Service Alert No: 1350

Title: 2016-2017 CX-3 EXCESSIVE WATER INTRUSION OR CONDENSATION OF HALOGEN HEADLIGHT
HEADLIGHT

Example of Light Unit With Condensation/Fog That Should Be Replaced

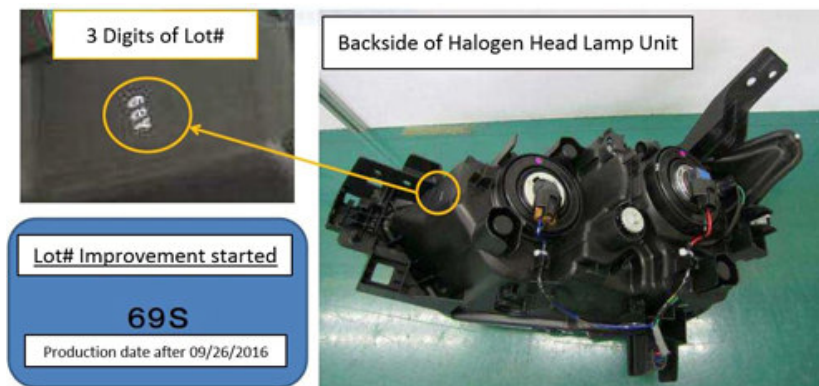
Some customers may complain of condensation/fog inside the front halogen headlight. The halogen headlight assembly may be the cause.

Heavy/large amount of condensation on the lens is not normal.

1. Verify if the condition requires repair. Refer to [TSB 09-003/16](#). Is a repair required?
 - a. Yes - Proceed to step 2.
 - b. No - This service alert does not apply.
2. Check the halogen headlight assembly lot number. Is the lot number before 69S?
 - a. Yes - Replace the headlight assembly.

Note: Verify that the new replacement part has a lot number of 69S or newer.
